**U.S. DEPARTMENT OF COMMERCE**  
**National Oceanic and Atmospheric Administration**  
National Ocean Service  
Office of Response and Restoration  
Assessment and Restoration Division  
290 Broadway, Rm 1831  
New York, New York 10007

April 26, 2010

Dear EPA and the Phase 1 Peer Review Panel:

## **Attachment 1. General Comments on GE's Report**

Figure 1. Total PCBs (mg/kg) top 2 inches West Channel Rogers Island

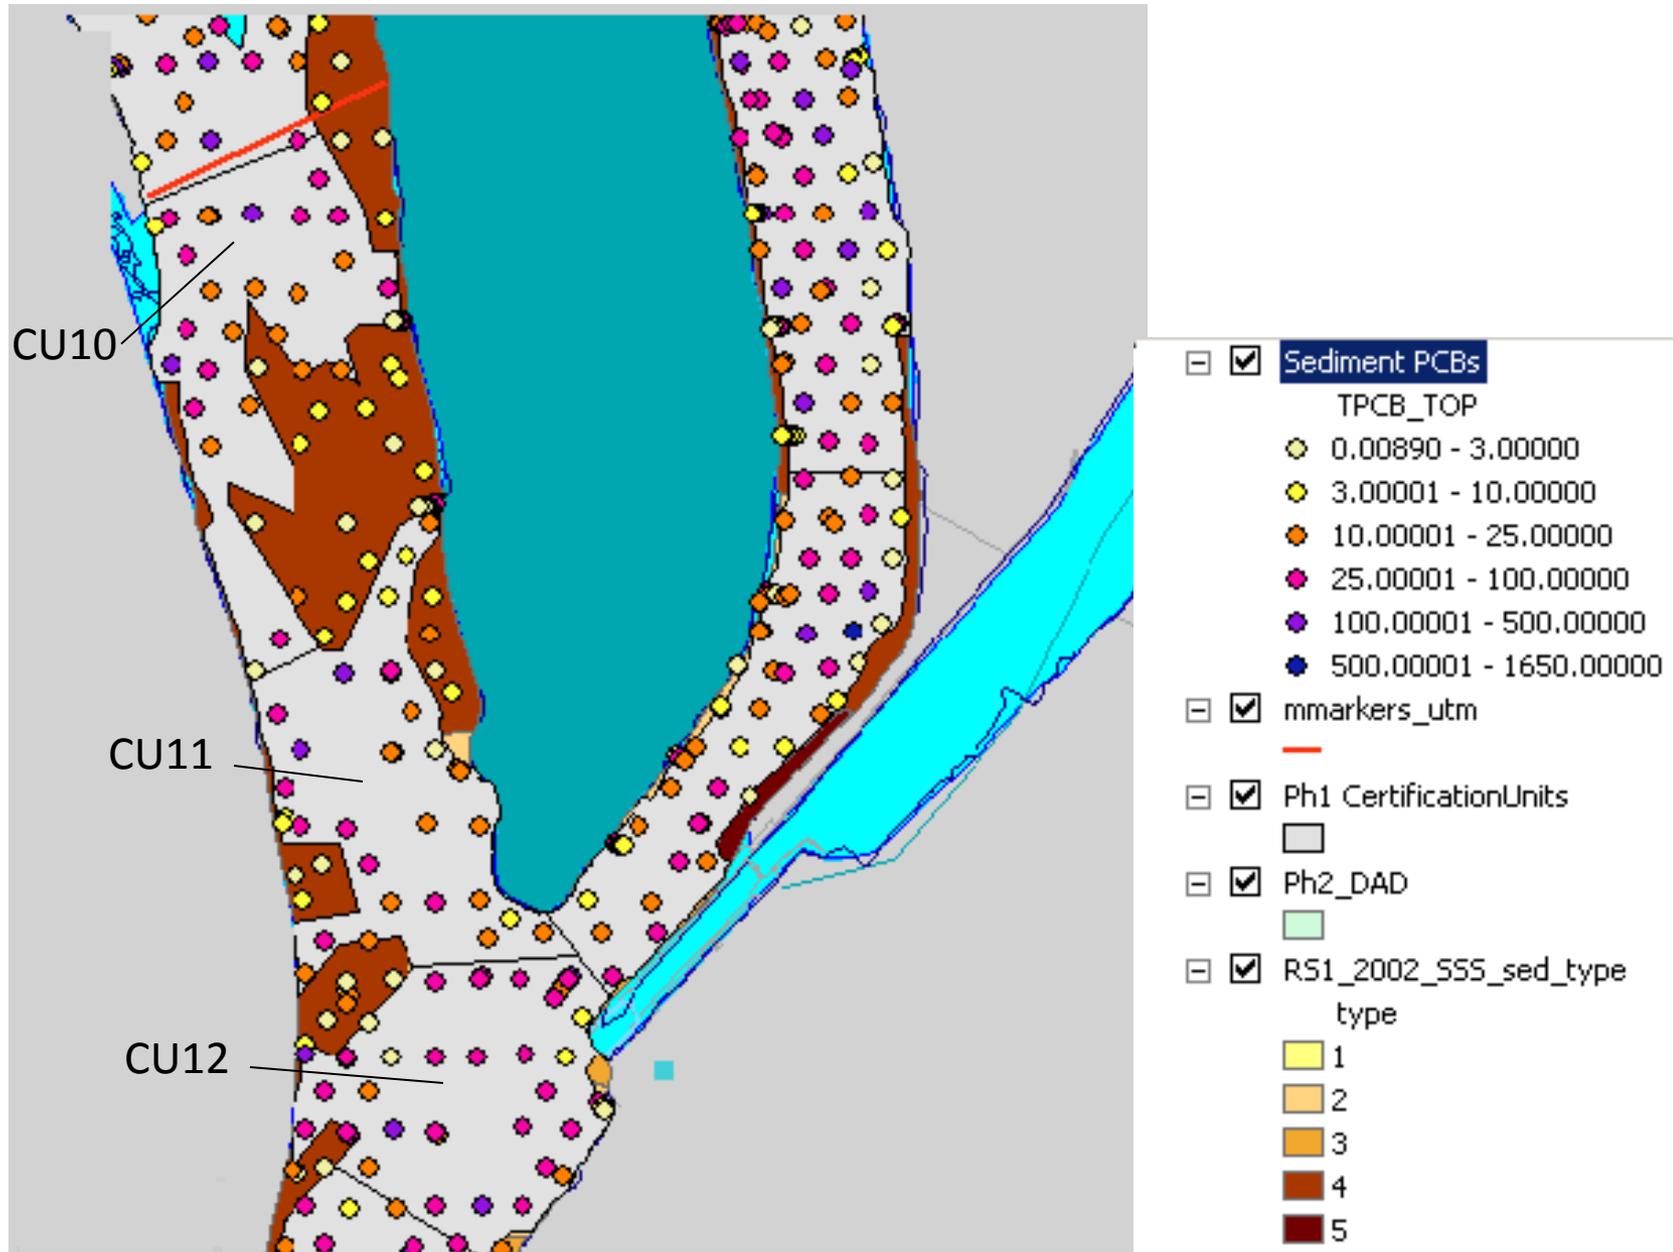
According to GE, dredging mobilized previously buried PCBs to downstream areas and deposited them on the sediment surface. Sediment traps were deployed immediately downstream of CU 10 and CU18, adjacent to CU11, and downstream of Phase 2 EGIA01B\_2, GI\_01\_KA and GI\_02\_KA dredge polygons. None of these areas were dredged in 2009 but highly contaminated sediments in the surface within these polygons could have been resuspended and captured within the traps by other events that normally occur during the year. Flows in 2009 were the third highest on record and the highest on record on the west side of Rogers Island due to construction of the rock dike in the east channel of Rogers Island. Figures 1 and 3 attached depict the PCB concentrations in the upper 2 inches in the vicinity of the traps. Figures 2 and 4 depict the locations of the sediment traps. Because adequate baseline data were not collected, GE's interpretation of the sediment trap data is questionable. The sediment trap study design cannot distinguish between sediment disturbed because of remedial activity or non-remedial events. Historic (1996) sediment traps were not placed in the same location as the Phase 1 sediment traps and therefore are not a suitable reference or point of comparison.

Moreover, the Phase 1 sediment trap data was only collected during remediation. Particle size distribution analysis documents sand comprising 38%-58% of the material in the traps deployed in July-August suggesting potential localized resuspension although infrequent high flows during this period also could have contributed to sediment redistribution unrelated to dredging. Also during part of this particular deployment period all dredging ceased for 5 days (August 7-11). No pre-dredging data from the same location is available. This is problematic due to the heterogeneity of sediment PCBs. Also, traps were not deployed to assess the natural movement of contaminated sediment under similar flow conditions. This is also a critical flaw given the observed changes in bathymetric surveys. In addition, cores were collected in 2009 for comparison to historic cores as part of the sediment trap study but only 7 out of 20 historic

coring locations (35%) were selected for re-sampling. Given the high surface sediment concentrations in the area of the traps and the high variability observed in co-located cores in the SSAP sampling, a more robust sampling design is necessary to evaluate changes in concentration. An analysis of the impact of a) deployment of the sediment traps, b) sediment disturbance and transport by boat traffic in the years prior to remedial dredging, c) uncontrolled releases of NAPL, and d) natural sediment movement within the system as documented by the changes in bathymetric surveys conducted between 2001 and 2009 do not appear to be accounted for.
